STAFF RECOMMENDATION 105 Broadway March 16, 2016

Application: Partial demolition; New construction – addition; Alteration – windows & doors

Description of Project: The applicant is proposing to make alterations to the front elevation, to construct side additions, and to construct a rooftop addition.

Figure 1: 105 Broadway, 1998 Photo

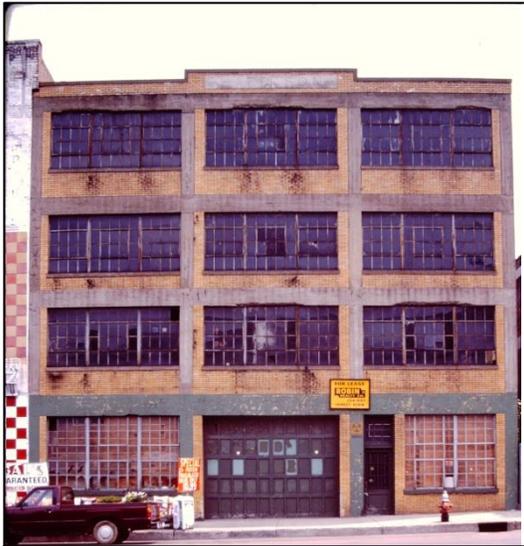
Background: 105 Broadway is a four-story building with a reinforced concrete frame and brick curtain walls, with a large central entrance and replacement windows on the front facade. The concrete columns divide the building into three bays on the front and ten bays on the side. The building was constructed circa 1935 to be a wholesale produce warehouse; it currently has a restaurant on the first story with offices above. The rehab includes changing the offices to restaurant/entertainment use.

A partial two-story addition on the roof of the building was constructed in the year 2000, prior to the enactment of the Broadway Historic Preservation Zoning Overlay. The original windows and doors were also removed in 2000. The upperstory windows and the left bay on the first story were replaced with contemporary storefront-type aluminum windows. The center loading-bay door and the bulkhead and window on the right first story bay were removed, creating an open vestibule and recessed storefront wall.

Figure 3: 105 Broadway, current conditions

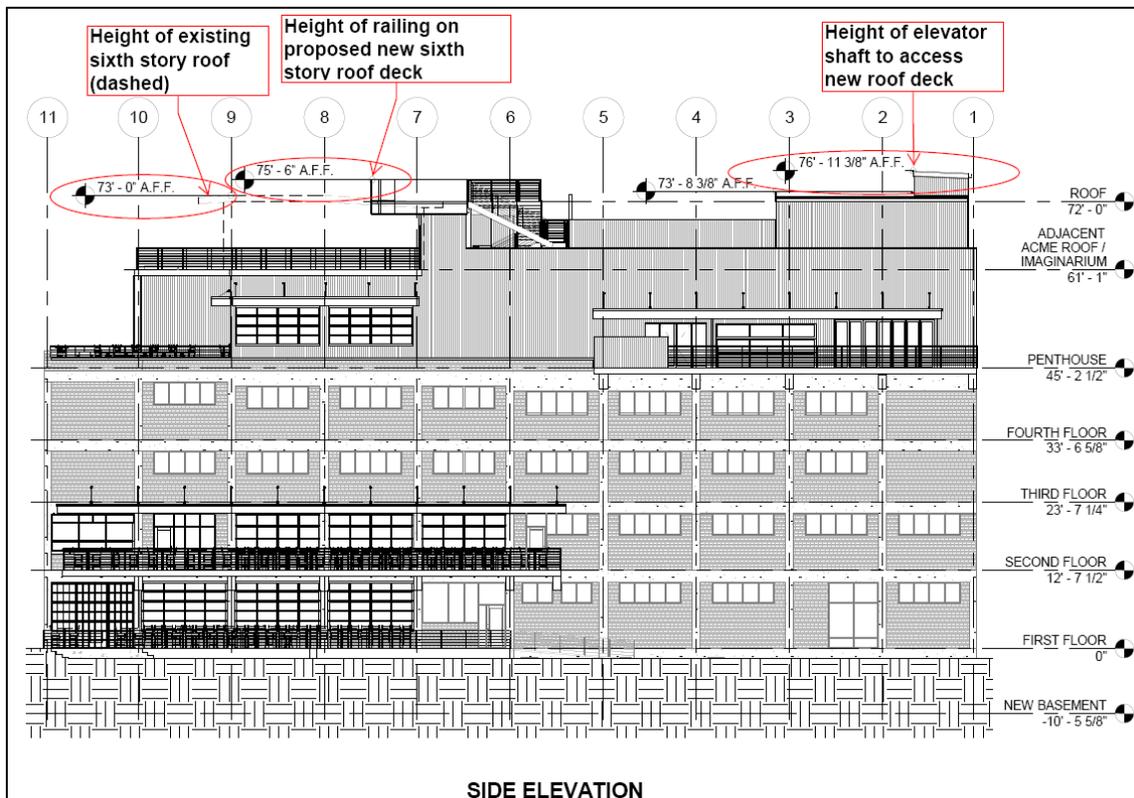
The proposal would reconstruct the right first story bulkhead wall and install new windows on the left and right first story bays. The bulkhead will be a buff or tan brick to match the original bulkhead and the windows will be roll-up or overhead windows with a multi-light configuration similar to the original windows. Staff finds the bulkhead reconstruction to meet guideline II.E.3 because the proposed design is more in keeping with the original configuration of the first level.

The window type is not appropriate as the guidelines require replacement windows to match the original design. In this case, there was originally a roll-up door but only within the central bay. Staff recommends the right bay be enclosed with a window to match the original windows. With that condition, the project meets sections II.H.3 and II.H.4.

The second story windows would be replaced with new aluminum overhead sectional windows that match the appearance of the existing windows. The existing windows are not original therefore replacement may be appropriate, but under guideline II.H.4, missing windows should be replaced with designs that replicate the appearance of the original window. In addition, rollup doors were never found historically on upper levels. With the condition that the replacement windows match the original windows, the project meets sections II.H.3 and II.H.4.

SIDE ELEVATION

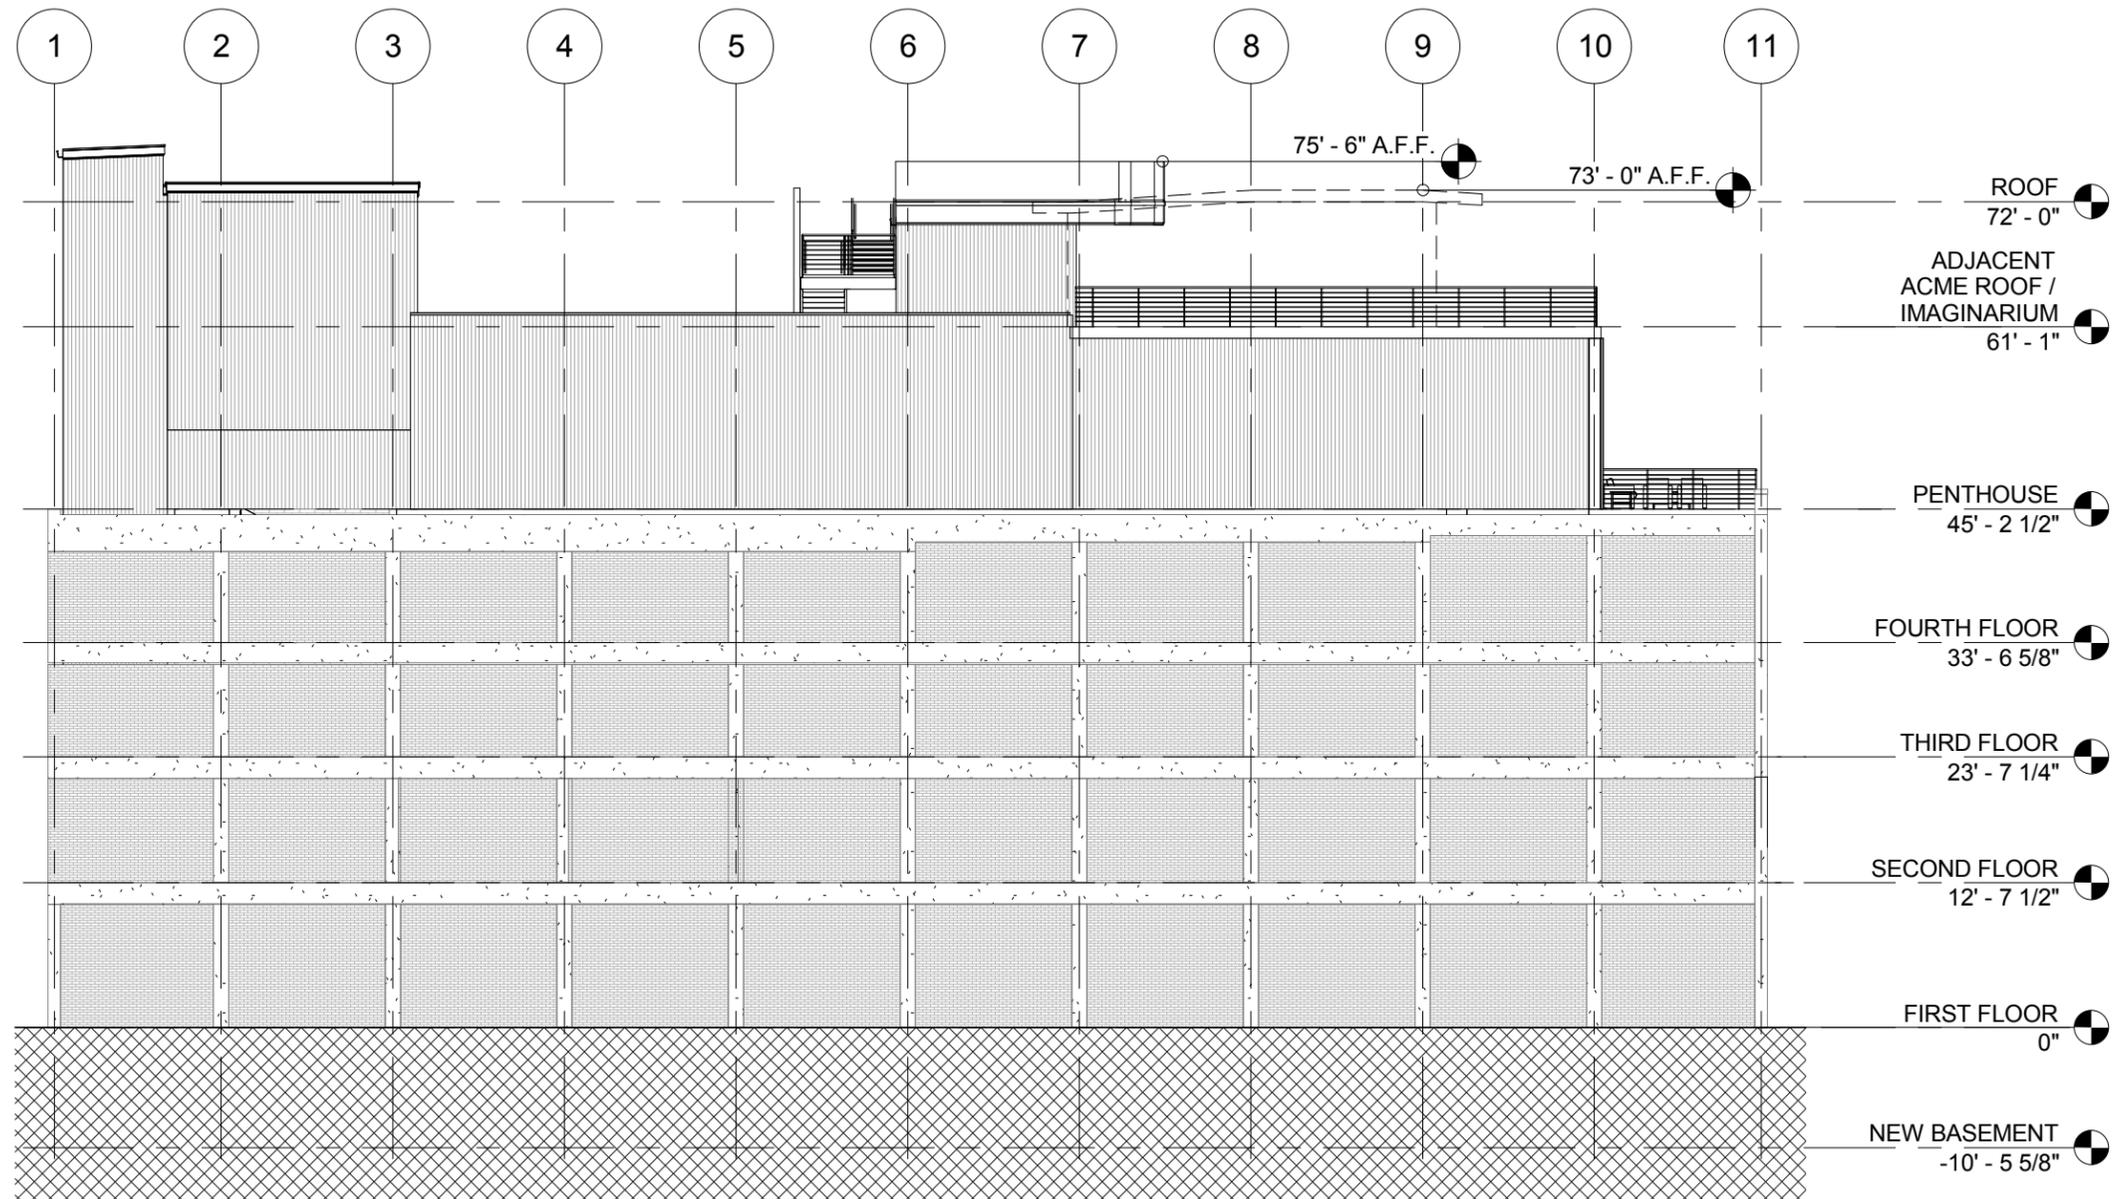
The open patio at the ground level will be retained. A multi-light overhead door is proposed to be installed in the first bay on the first story. Although the right side of the building originally faced an alley, Staff considers the first bay on the right side of the building to be a public façade because this portion of the building is highly visible from

There may not have been a window at this location originally; however, when the original front wall was removed it created an opening in this location. Because it is an “existing condition,” staff finds a new window may be appropriate. When there is no longer evidence of an original window, the design guidelines require that the new window be appropriate for the building’s style and period. Since the buff brick of the front façade wraps this first bay, staff finds that the new window should match the replacement window of the front of the building which, as described previously, should match the original window design. An overhead door does not meet this requirement and does not meet sections II.H.3 and II.H.5 of the design guidelines. With the condition that the side, first level replacement window match the design of the front replacement window, staff finds the project to meet sections II.H.3 and II.H.5 of the design guidelines.

The second through fourth bays of the first story are also proposed to have overhead sectional windows, with the lower portion of the existing wall retained as a bulkhead. Altering original walls and window proportions would not be appropriate on a primary façade, but because these are behind the first bay where the wall has a different color brick, Staff considers these to be on a secondary façade. However, with the exception of loading docks, including the front of this building and the basement-level rear-facing facades on First Avenue, rollup doors were not found historically in the district. With the condition that the new windows are appropriate for the building’s style and period, which would not include overhead roll-up windows, staff finds that altering the side, first level windows would meet sections II.H.3 and II.H.5 of the design guidelines.

The proposal includes the installation of new storefront-type windows in the first and second bays of the second story. Unlike the first bay on the first story where the original wall was previously removed, the second story wall is intact, and as a public façade it would not meet design guideline II.H.5 for new window openings to be introduced in the first bay. Because the second bay is not considered a public façade, introducing new windows may be appropriate. The third through fifth bays are also proposed to have overhead sectional windows, with the lower portion of the existing wall retained as a bulkhead. Altering original walls, introducing new windows, and altering existing window proportions would not be appropriate on a primary façade, but Staff considers the side wall behind the first bay, where the wall has a different color brick, to be a secondary and that these undertakings may be appropriate. However, when replacing windows, the design guidelines require that new windows be appropriate for the building’s style and period. Overhead windows are not typical of the upperstory of historic buildings and would not meet guideline II.H.5. With the condition that new windows are not added in the first bay and that new windows in the other bays match the style of the original windows, Staff finds that the project meets sections II.H.3 and II.H.4.

A projecting cantilevered balcony is proposed at the second floor level, beginning three feet (3’) back from the front edge of the building and extending back eighty feet (80’) with a continuous canopy above at the level of the third floor. With the right side alley

having been closed, a condition which would not be likely to be repeated elsewhere, this property is unique in having a side yard (half the original alley) in which to expand. In addition, this “side yard” is not wide enough to accommodate an addition that could look like another building, which would typically be the requirement or even another bay of the existing design. For that reason, Staff finds that a side addition may be appropriate; however, guideline II.H.I states that balconies shall not be added to public facades. Because of the visibility of the first bay and because the brick matches that of the front façade, Staff finds that the balcony would need to begin behind the second bay, fifteen feet (15’) back from the front of the building. Additionally, Staff recommends that the canopies be confined to the area directly over the window openings as would be typical of historic window awnings.

- New windows on the first and second stories on the right side of the historic building shall be appropriate for the building's style and period, which would not have included overhead sectional windows;

- The second-floor balcony shall begin at the second bay, fifteen feet (15') back from the front of the building;
- Awnings above second-level balcony should be limited to the area directly over the window openings;

ISOMETRIC VIEW

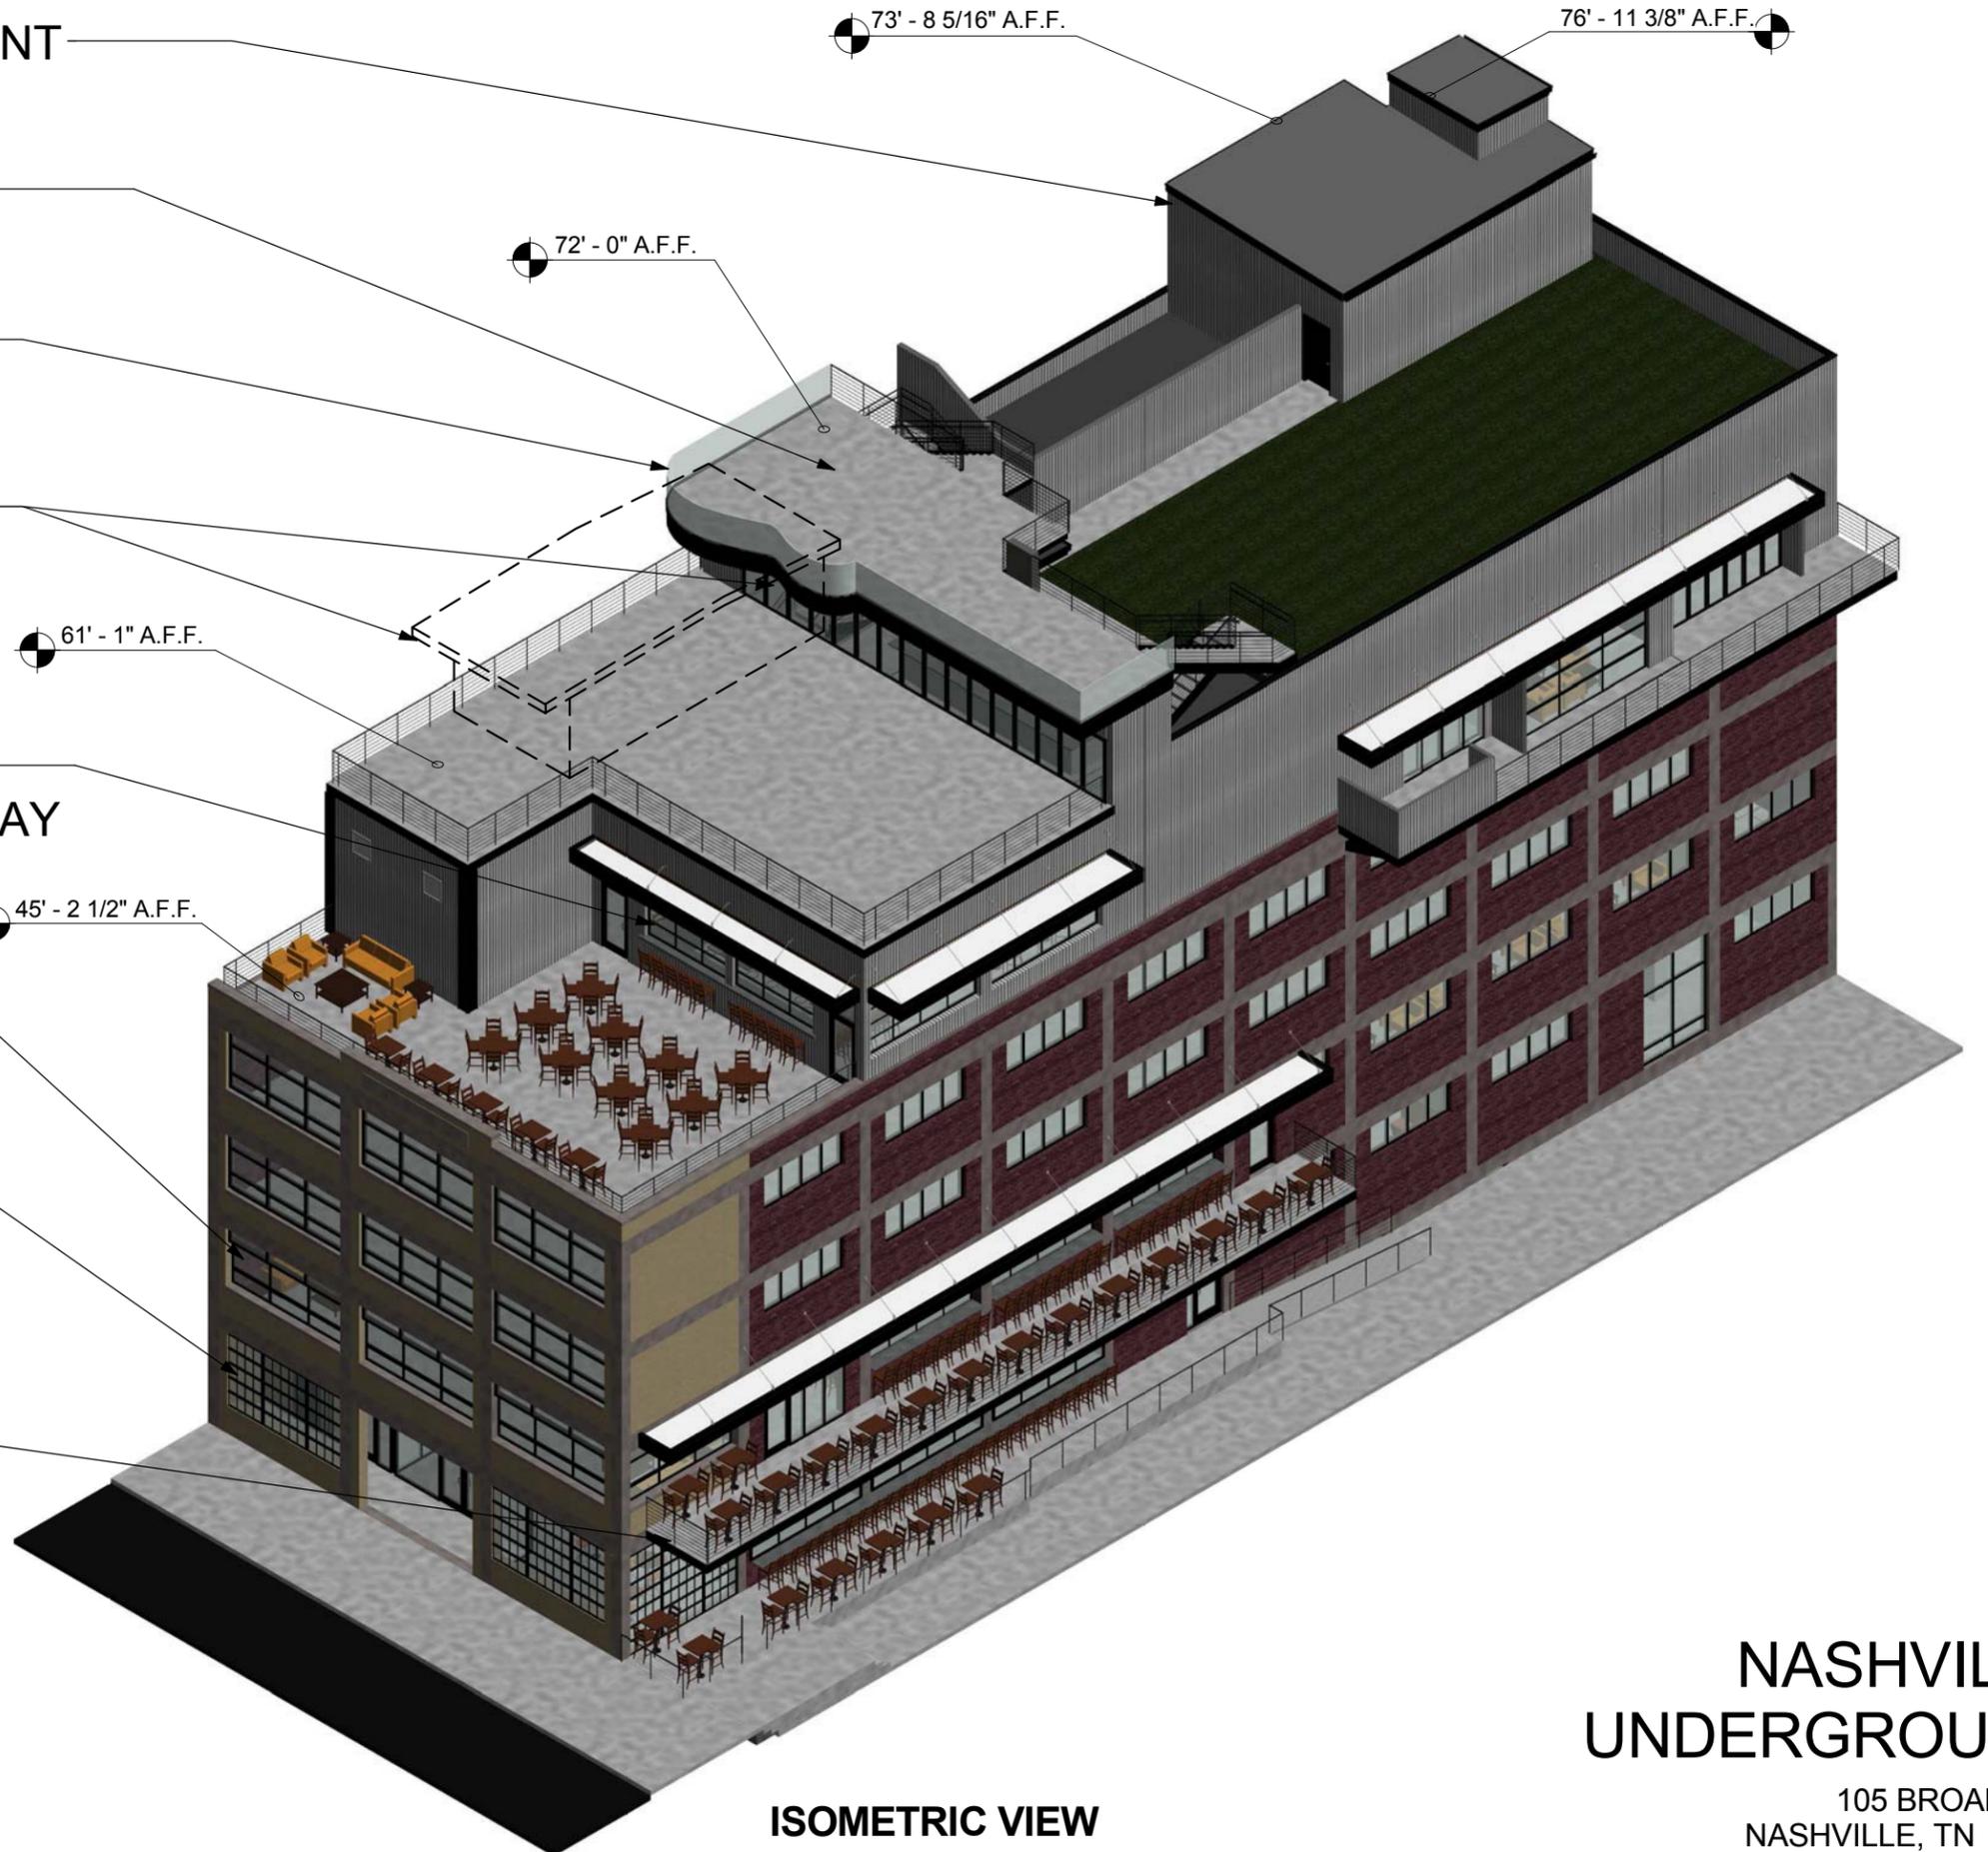
The addition constructed in 2000 created a partial fifth and sixth story to the building above the left bay, step backed fifteen feet (15’) from the front wall with a railing above the parapet. The proposed new addition will expand the fifth story across the full width of the historic building, with the new portion stepped back thirty feet (30’) from the front of the building, which is more in keeping with the current design guidelines.

The roof height of the fifth story will be thirteen feet, two inches (13’-2”) above the top of the original parapet, which is in keeping with the design guidelines; however, the applicant proposes to top the addition with a forty-two inch (42”) tall railing to create a deck above. Although this matches the height of the existing fifth floor addition, the railing is twenty-two inches (22”) taller than what section III.H.2 of the design guidelines allow. Staff recommends that the height of the new fifth story, including any railing above the roof, be no more than fifteen feet (15’) taller than the parapet of the front wall in order to meet the design guidelines and that the railing be changed to a parapet wall.

The existing sixth floor of the 2000 addition is to be demolished, and a new space will be constructed fifty-two feet (52”) back from the front edge of the building. This new 6th story will extend the entire width of the building and the roof height will be one foot (1’) shorter than the existing 6th floor, but it will have roughly the same square footage as the

existing space and will be set back twenty-four feet farther back from the front wall. The design guidelines only allow additions to be one story above the form of an historic building. The construction of a partial sixth story does not meet section III.H.2 of the design guidelines, however, Staff finds that permitting the proposed addition in exchange for removing the existing sixth story will result in a more appropriate appearance as the new addition is set farther back and will be less visible. However, this level is also proposed to have a roof deck with a railing at seventy-five feet, six inches (75'-6") above the finished first floor, accessed by an elevator shaft to the rooftop which would be seventy-seven feet (77') tall. Included is a walkway leading to the guitar shaped deck. The walkway, railing, and elevator increase the height and scale of the addition, which is replacing an addition that already exceeds the Broadway design guidelines. Without the deck, which is not present on the existing addition, these taller features would not be necessary. Staff recommends that the upper roof deck be eliminated and that the new addition is no taller than the existing addition.

- The height of the new fifth story shall be no more than fifteen feet (15') taller than the parapet of the front wall of the historic building and any railing necessary shall be parapet wall;

- The height of the new sixth story, including any railings, stairs, or elevators, shall be no taller than the existing addition and shall not include a rooftop patio; and,
